Report on Consultation - Route Selection

Project: LT313 Earraghail Wind Farm OHL Connection

Date: January 2023

Plate 3.1 – Preferred Route

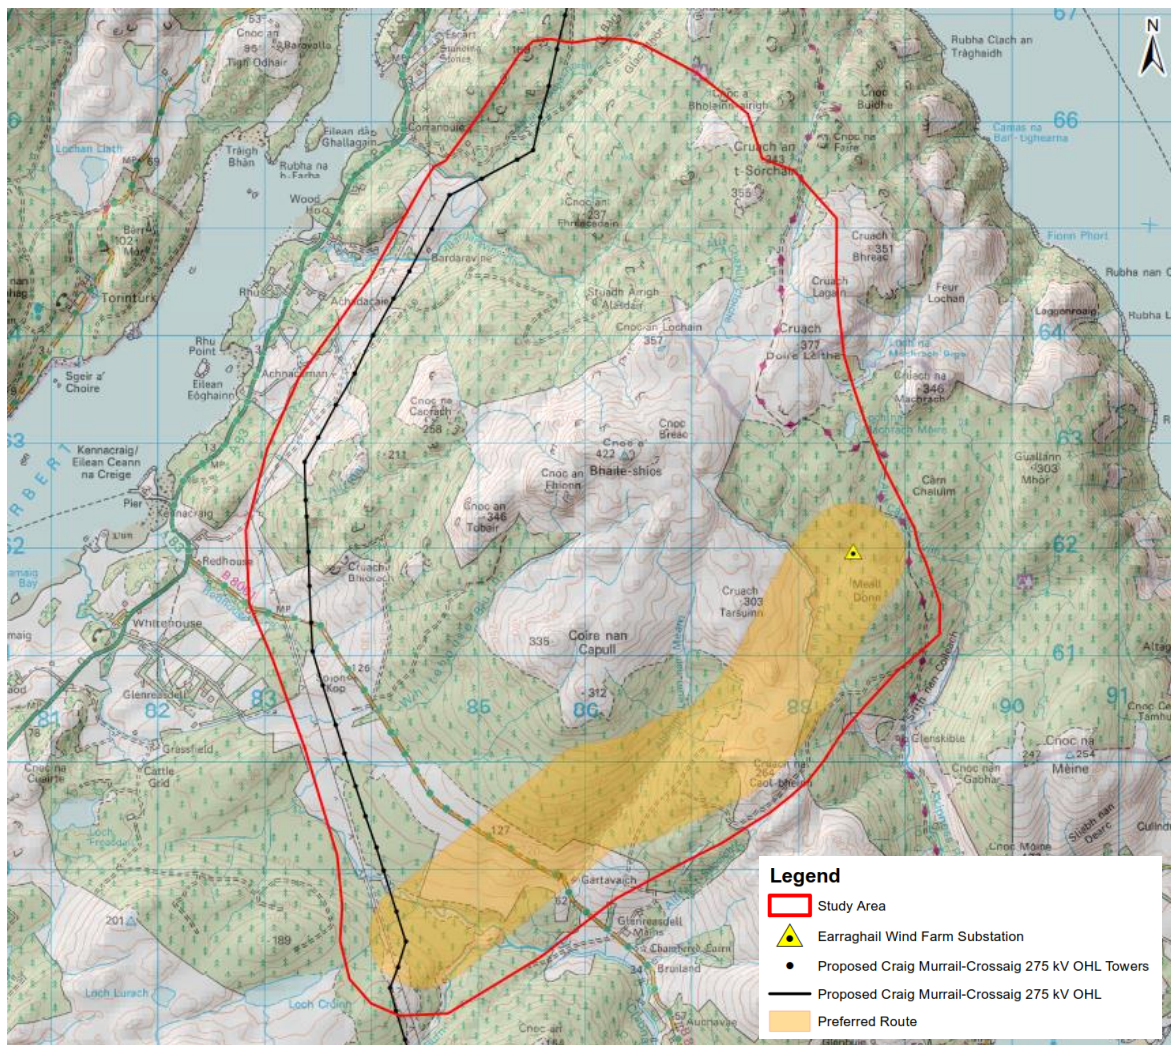
HES	<p>We note that the preferred route is currently route 1B. This route would have the potential impacts on the setting of Glenreasdail Mains, chambered cairn 200m SE of, SM3281. Route options 1A & 1B are the least-preferred options for our interests, but we are content that these could be minimised with further detailed assessment and careful design.</p> <p>The cultural significance of chambered cairns is heavily vested in the specifically local details of their settings, as such the setting of this cairn is very sensitive to change. Should Route Option 1B be progressed, we recommend that mitigation by design is undertaken to minimise impacts on the setting of the chambered cairn. This is likely to require the careful positioning of the overhead line so as to maximise the absorbing effect of the surrounding</p>	<p>SSEN Transmission acknowledge the potential for impacts on SM 3281. The asset has been considered in the route options appraisal. Further environmental studies will be undertaken at the alignment stage which will consider the potential for impacts on cultural heritage sites and assets. It is considered an acceptable alignment that minimises potential effects on cultural heritage sites and assets within the Preferred Route can be found. SSEN Transmission will continue to engage with HES</p>

RSPB	<p>SPECIES</p> <p>RSPB Scotland note that Route Option 1b is presently preferred by the Applicant. We are broadly supportive of this selection on the basis of minimising transiting of open ground habitats; however our data indicate that Route Option 1B passes closer to 2 black grouse <i>Lyrurus tetrix</i> areas of Highest Regional Priority than Route 1A.</p> <p>Black Grouse</p> <p>Argyll Native woodland comprises important black grouse habitat at a low density of ≤ 200 stems/ha. Black grouse are vulnerable to collision with unmarked barriers such as OHLs and fence lines. Data indicates that 3 areas of Highest Regional Priority and 1 area of High Regional Priority are located < 1.5 km from Route Option 1B. Route Option 1B sits well within the 5 km adult dispersal zone for 4 regionally important black grouse leks, and any degradation/loss of low-density native/Ancient Woodland could result in significant negative impacts for this special at Regional scale. Robust fieldwork will therefore be required to ascertain current levels of black grouse activity; and whether, if good numbers of birds are still present, any potential negative impacts of Route Option 1b can be mitigated.</p> <p>Raptors</p> <p>Historical data indicate that golden eagle <i>Aquila chrysaetos</i> breed to the north-west of the proposed Crossaig substation within the Study Area. Route Option 1B passes furthest from this site. White-tailed eagle activity has also been recorded through the Study Area.</p> <p>The cumulative impact of renewable energy developments/peripheral infrastructure on Kintyre's territorial pairs must be given fulsome consideration to safeguard these iconic birds, which are protected under Schedule 1, Schedule A1 and Schedule 1A of the Wildlife and Countryside Act 1981.</p>	<p>SSEN Transmission note RSPB's comments on the Preferred Route. The potential for impacts upon Black Grouse and Raptors were considered within the Consultation Document and will continue to be considered through future design stages and assessment work as we seek to find an acceptable alignment that minimises potential effects on these sensitive species.</p> <p>Consultation with Argyll Raptor study group will be undertaken at the alignment stage with regards to the scope of ornithological surveys and any relevant data they may hold.</p> <p>Opportunities for habitat enhancement, i.e. blanket bog restoration and connectivity will be considered in line with SSEN's Routeing Guidance.</p> <p>SSEN Transmission recognise the importance of establishing a holistic approach to assessment. The potential cumulative impact is considered in the development and appraisal during routeing as well as part of the EIA.</p> <p>Cumulative impacts will be taken into consideration with other environmental, engineering and economic factors to select a proposed alignment which is economically viable, technically feasible, minimises impacts on important resources or features of the environment and reduces disturbance to those living in it, working in it, visiting it or using it for recreational purposes.</p>

TSCC	<p>TSCC notes that the planning application and EIA for the proposed Earraghail RED did not include the positioning of the substation or grid connection routes, although acknowledges there is no fixed criteria for applications in this regard. TSCC recommends this information be provided in advance to communities and consultees for all EIAs.</p> <p>TSCC states:</p> <ul style="list-style-type: none"> • The height of proposed pylons (80m) are the same used through the transmission network. Impacts would be the same as those we can observe now between Lochgilphead and Whitehouse, which are considered severe. • Poor judgement in the planning of the line has prioritised costs to the developer over localised impacts, including a detrimental effect on the value of some local property and viability of businesses, as well as unnecessary environmental impacts. • A number of complaints have been made regarding the inconsiderate behaviour of contractors during the construction phase. E.g. quarrying beginning at 7am on a Sunday morning at the pinch point at Tarbert. • SSE made it clear to us that the preferred route would be 1B with 1A being secondary. The grounds stated being that this is simplest from an engineering perspective and therefore most cost effective. 	<p>The positioning of the cable sealing end compound will be included in the EIA Report.</p> <p>The height of the steel lattice towers will be approximately 46 m in height, the use of visualisations to demonstrate the impact of the OHL will be considered as part of the EIA.</p> <p>The overall Preferred Route was determined following an assessment of a range of environmental, engineering and economic factors. SSEN Transmission acknowledges the potential for impacts on the environment, however further environmental studies will be undertaken at the alignment stage. It is considered that an acceptable alignment that minimises potential environmental effects can be found.</p> <p>At this stage construction hours have not been confirmed, these will be agreed with Argyll and Bute Council prior to the commencement of works.</p> <p>All Route Options would be potentially visible from the B8001, Kintyre Way and people involved with outdoor pursuits. SSEN Transmission acknowledges the potential for impacts on visual amenity, however the landform and natural screening within the</p>

Stakeholder	Summary of Feedback	Response by SSEN Transmission
	<ul style="list-style-type: none"> • Route 1 can be seen to be the worst from the perspective of loss of residential visual amenity, and also the loss of visual amenity from the B8001 trunk road serving the communities of East Kintyre and connecting tourist traffic between the ferry routes to the isles. • This vista to the south has already been radically transformed and will soon be a fully industrialised landscape. • Earraghail wind farm and grid connection will result in the development on the other side of the road, compounding this impression, resulting in a corridor or industrialised energy infrastructure. • Homeowners in the area, who have already suffered significant losses the re-sale value of their properties, will be yet further undermined with a number concerned that they will be able to find a buyer at all. • The most severely affected properties include: Gartavaigh, Glenreasdell House, Spyiancop and the cluster of houses at the top of Whitehouse Burn. • Route 1 is likely to have the most severe impact on cultural history and archaeological remains, including old shielings and the chambered cairn behind Glenreasdale, a scheduled monument. It will also have the highest level of visibility from the historical Glen Skibble valley and probably Skipness and Claonaig additionally. 	<p>area will be utilised where possible to screen views from these receptors. Further environmental studies will be undertaken at the alignment stage, it is considered that an acceptable alignment that minimises potential visual amenity effects can be found.</p> <p>SSEN Transmission acknowledge the potential for impacts on SM 3281 and the 11 undesignated assets within the Preferred Route. These assets have been considered in the route options appraisal. Further environmental studies will be undertaken at the alignment stage which will consider the potential for impacts on cultural heritage sites and assets. It is considered that an acceptable alignment that minimises potential effects on cultural heritage sites and assets within the Preferred Route option can be found.</p>

Stakeholder	Summary of Feedback	Response by SSEN Transmission
	<p>landform and to minimise the impact of skylining on inwards and outwards views. We recommend that this design process should be informed by an assessment of impacts on heritage assets and their settings. Any such assessment should be undertaken by a suitably qualified professional and meet the requirements of Scottish Planning Policy (SPP, 2014), the Historic Environment Policy for Scotland (HEPS, 2019) and associated Managing Change Guidance Notes. Additional guidance on cultural heritage impact assessment can also be found in the Cultural Heritage Appendix to the EIA Handbook (SNH, HES, 2018).</p>	<p>through subsequent project stage, including discussion on potential mitigation.</p> <p>The use of visualisations to demonstrate the impact of a replacement OHL will be considered as part of the EIA forming part of the Section 37 Application.</p>

Stakeholder	Summary of Feedback	Response by SSEN Transmission
	<p>RSPB Scotland strongly recommend that the Applicant liaises with the Argyll Raptor Study Group to ensure full capture of site occupancy/breeding data for these sensitive species.</p> <p>HABITATS</p> <p>RSPB Scotland urge the applicant to be ambitious in any mitigation and enhancement proposals for blanket bog restoration, positive moorland management and the connecting of Ancient Woodland fragments both on and off site. This approach would provide valuable habitat in Kintyre for raptor prey species and Regionally Important black grouse populations by creating diverse transitional zones.</p> <p>CUMULATIVE IMPACT</p> <p>An assessment of cumulative bird impacts in relation the other operational, consented and proposed developments in the planning system within this Natural Heritage Zone is essential. RSPB strongly advise that a holistic landscape management plan is established between energy developers and landowners.</p>
